DOMINION NUCLEAR CONNECTICUT, INC.
MILLSTONE POWER STATION UNIT 3
RESPONSE TO REQUEST FOR ADDITIONAL INFORMATION REGARDING
STRETCH POWER UPRATE LICENSE AMENDMENT REQUEST
REVISED RESPONSE TO QUESTIONS EEEB-07-0052, EEEB-07-0054 AND
EEEB-07-0055

Stretch Power Uprate License Amendment Request
Response To Request For Additional Information
Revised Response To Questions EEEB-07-0052, EEEB-07-0054
And EEEB-07-0055

NRC Question EEEB-07-0052 Follow-Up (EEEB-08-0108)

Figure 1: Pre- and Post-SPU Environmental Temperature Profiles

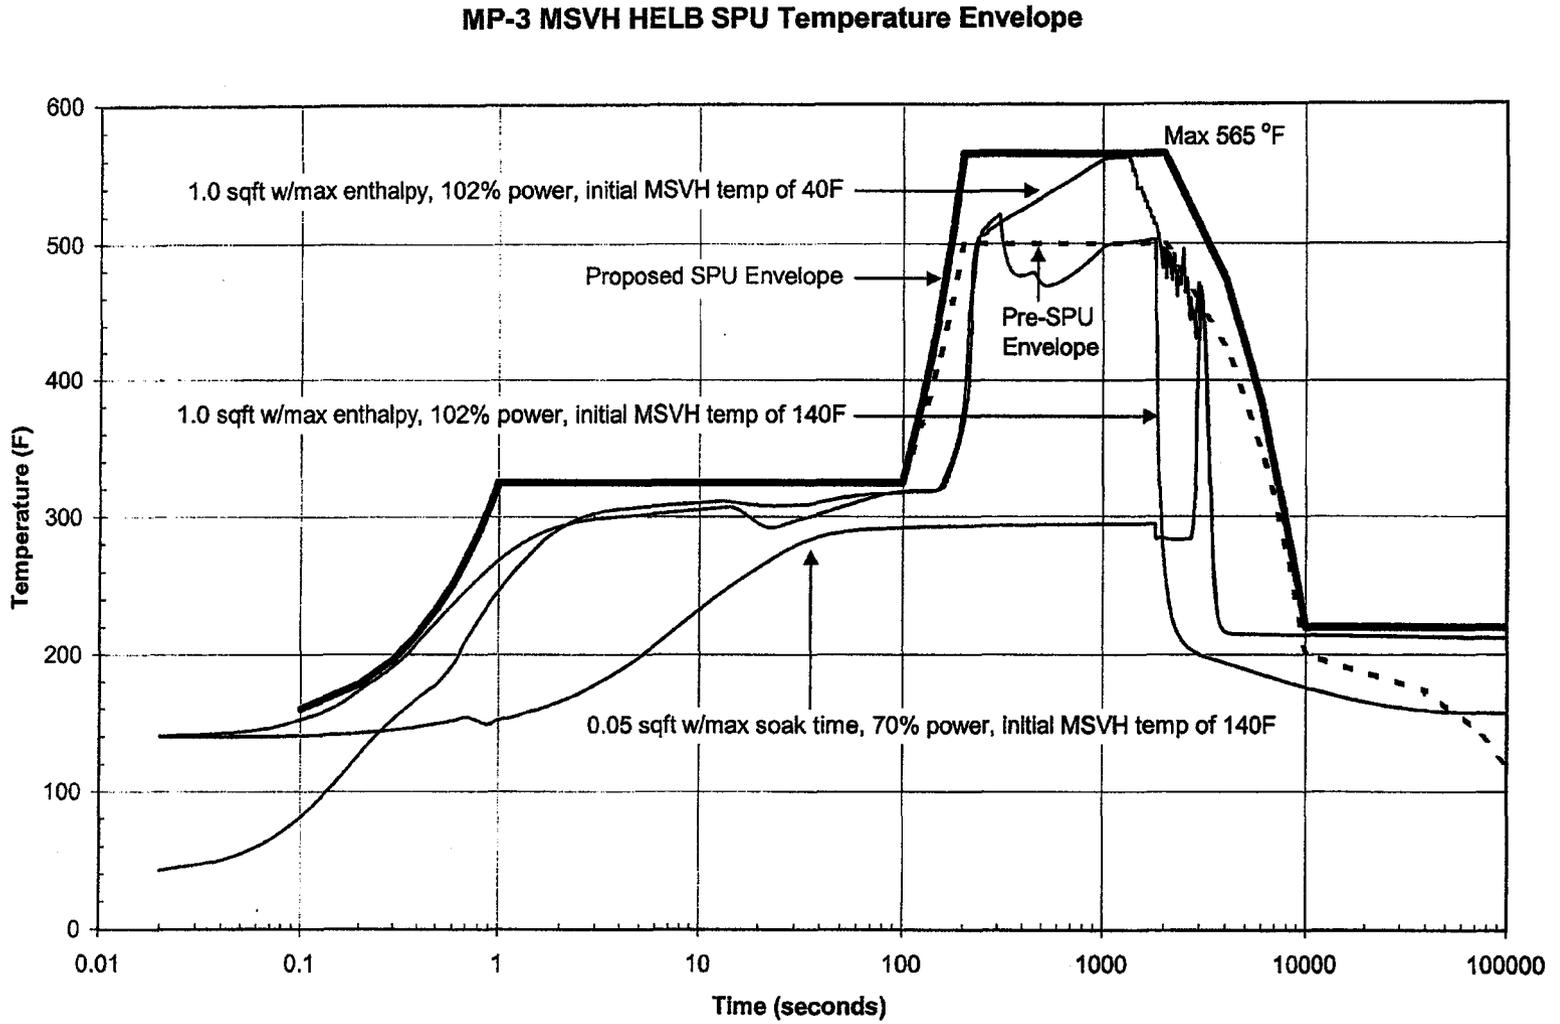
In the March 25, 2008, letter, the licensee states that the analysis for the Main Steam Valve Building (MSVB) following a main steam line break (MSLB) is performed for the duration of the component's mission time. Specify the mission time and function for each of the affected components in the MSVB. Describe the effects of the increased temperature and pressure on the affected components. In addition, explain, in detail, the assumptions and methodology used to evaluate the components. Provide a comparison of the pre-stretch power uprate (SPU) and SPU environmental temperature and pressure profile. Also, provide the detailed environmental qualification (EQ) evaluations and calculations for the ASCO solenoid valves, NAMCo limit switches, Rosemount pressure transmitters, Limatorque motor-operated valves and solenoids associated with Sulzer main steam isolation valves (MSIVs) and ITT actuators.

Provide the worst-case breaks and their impact on the EQ components for the MSVB EQ analysis.

A comparison of the enveloping pre- and post-SPU environmental temperature profiles is provided in Figure 1. The current EQ pressure profile envelopes post-SPU pressure profiles for all cases analyzed. Therefore there is no change to the EQ pressure profile. The enveloping EQ pressure profile is shown in Figure 2.

Figure 4: Post-SPU Namco Limit Switch Temperature Profiles

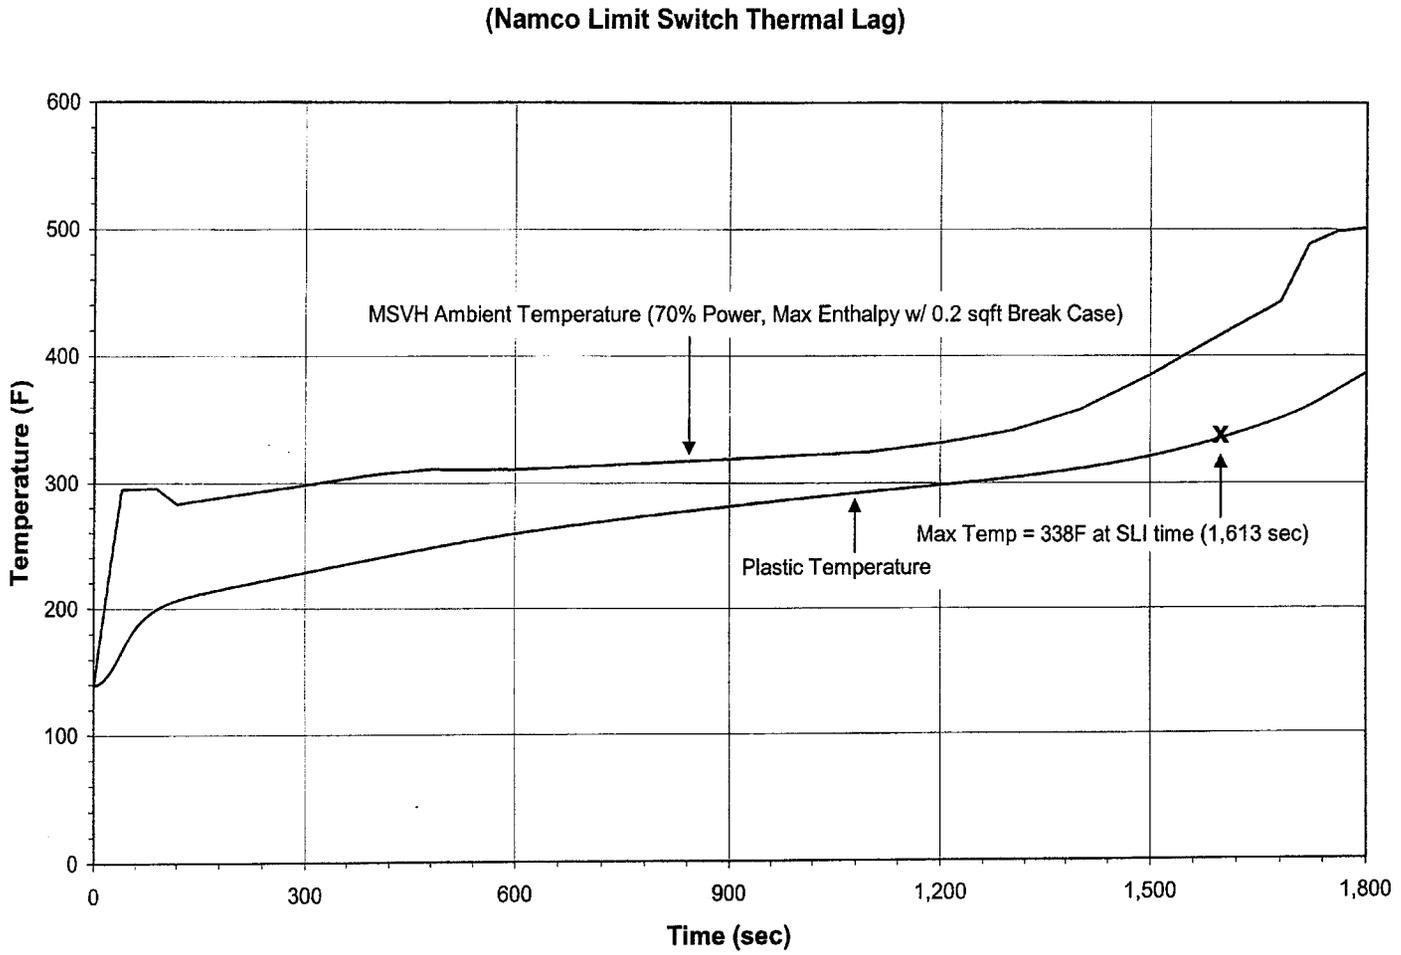
In the March 25, 2008, letter, the licensee states that the outside temperature (i.e. component casing temperature) of the equipment, instead of the internal temperature of the equipment, was conservatively compared with the component qualification temperature. Provide a basis for why the outside temperature is conservative for the affected EQ components.

Unlike the thermal lag analysis for the ASCO solenoid valves, a bounding 1800-second mission time was not used for the NAMCO limit switches. Instead, the thermal lag analysis used the mission time for each specific break size that was determined in the HELB analysis (i.e., for each break size, the temperature is calculated for the period starting from break initiation until the MSI signal is received). The analysis for all break sizes used their corresponding worst case temperature profiles (i.e., 102% SPU NSSS power level, maximum enthalpy). Additionally, the 0.2 ft² break size was analyzed using 70% SPU NSSS power level, and maximum enthalpy temperature profile, which resulted in the highest peak temperature. This is because MSI occurs much later for the 70% SPU NSSS power level case than the 102% SPU NSSS power level case. MSI for the 0.2 ft² HELB at 70 % power case occurs at 1613 seconds. The calculation assumes an initial casing temperature of 140°F. The calculated temperature of the phenolic inner casing at 1613 seconds is 338°F, which remains less than the 340°F qualification temperature for the most limiting NAMCO limit switch model. Post-SPU ambient and component temperature profiles are provided in Figure 4.

Figure 6: Post-SPU Limitorque Motor Temperature Profiles (with insulation)

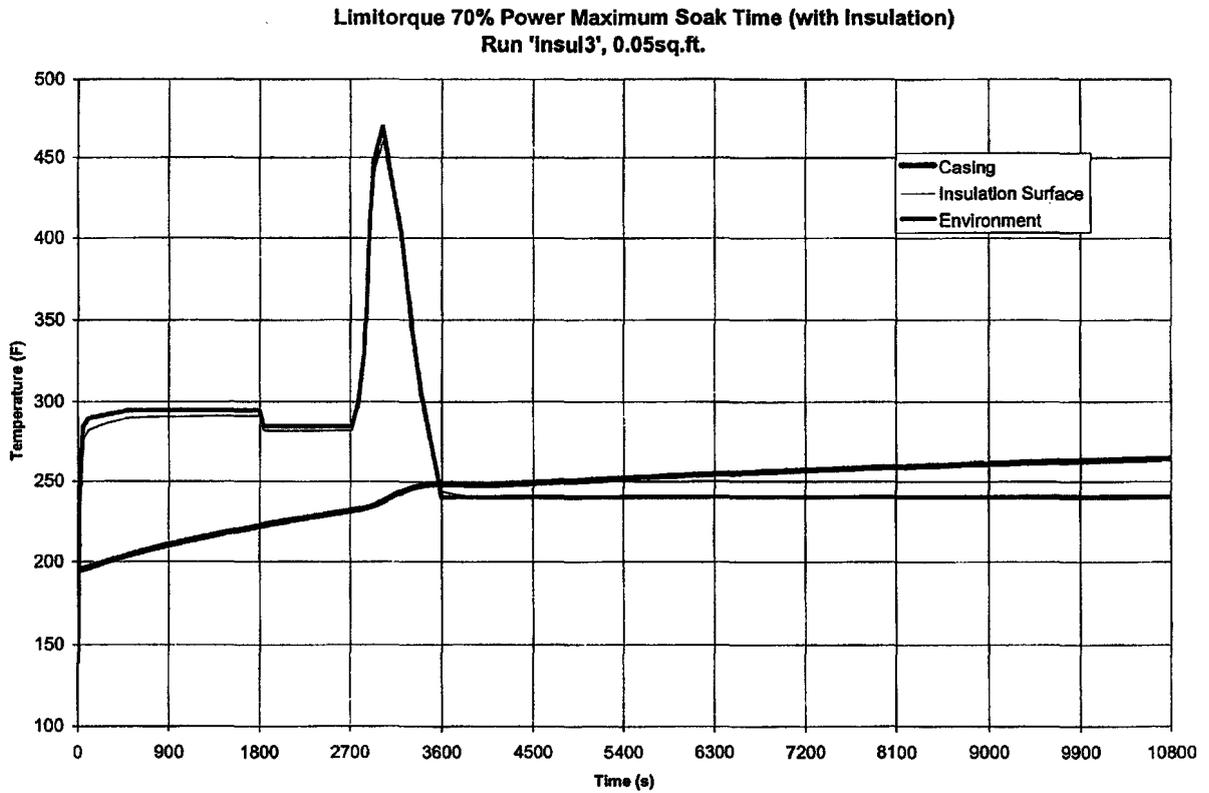
During the March 31, 2008, teleconference, the licensee stated that due to the temperature increase in the MSVB, a design change (enclosing the Limitorque motors with insulation) will be required to maintain the qualification of the motors. Describe the design change in detail and provide a detailed evaluation justifying how this new design, (enclosing the motors with insulation), does not impact the original qualification configuration of the Limitorque motors. In addition, provide a schedule for implementing the aforementioned design change.

Do the motor-operated valves installed in the MSVB use magnesium rotors? If yes, then evaluate the impact of high temperatures on the motors due to the SPU to ensure that these motors do not experience the failure mechanism identified in Information Notice 2006-26 and industry operating experience.

The subject valve bodies contain steam during normal operation. Therefore, the analysis used initial motor casing surface temperatures that are higher than the initial ambient temperature. The analysis was performed using temperature profiles from 0.05 ft² and 0.1 ft² break sizes (double ended guillotine break for a 3-inch diameter line). Four cases for each break size were analyzed: 1) maximum enthalpy at 102% SPU NSSS power level, 2) maximum enthalpy at 70% SPU NSSS power level, 3) maximum soak time at 102% SPU NSSS power level, and 4) maximum soak time at 70% SPU NSSS power level. These cases were chosen to be bounding since they provide the temperature versus time profiles for maximum peak temperature and maximum time for exposure of the component to an elevated temperature prior to superheat and the maximum temperature at the end of the analysis time. The analysis shows that 3MSS*MOV18A/B/C/D motors require insulation to maintain the motor temperature below the qualification temperature during the MSVB HELB event. The most limiting case with insulation was determined to be the maximum soak time at 70% power, 0.05 ft² HELB, insulated case.

The peak MSVB environmental temperatures for all eight cases occur well within 3,600 seconds after break initiation. Therefore, the analysis was run for a period of 10,800 seconds (3 hours). Although the environment temperature drops rapidly after one hour, the analysis assumed a 240.5°F temperature for the remaining portion of the transient. In addition to the external heat flux from the harsh environment to the motor casing, the analysis assumed conductive heat flux from the valve to the motor casing. Therefore comparison of the higher casing temperature to the qualification temperature is conservative. The insulated motor casing temperature at 3 hours is 265°F, which is less than the 315°F motor qualification temperature. Post-SPU temperature profiles of the ambient and the motor casing are provided in Figure 6.

As part of SPU project implementation, a design change will be performed to insulate the 3MSS*MOV18A, B, C and D operator motors prior to exceeding 3411 MWt. The subject motors are totally enclosed, non ventilated motors manufactured by Reliance and do not use magnesium rotors. They are qualified for 100% relative humidity. The design change proposes to install 1.5 inch thick

flexible blanket type insulation covering only the motor. Enclosing the motors with insulation is expected to increase the motor temperature during normal operation and thus, any impact that would reduce the motor service life will be evaluated. The design change process will evaluate the proposed modification to ensure that the installed condition will maintain the original motor qualification (i.e., test condition is applicable to the installed condition). Casing temperatures will be monitored pre- and post-modification, and any impact on the qualified service life will be incorporated into the EQ program for these motors. As part of the design change, plant procedures will be updated such that the motors will be inspected more frequently and replaced when necessary.
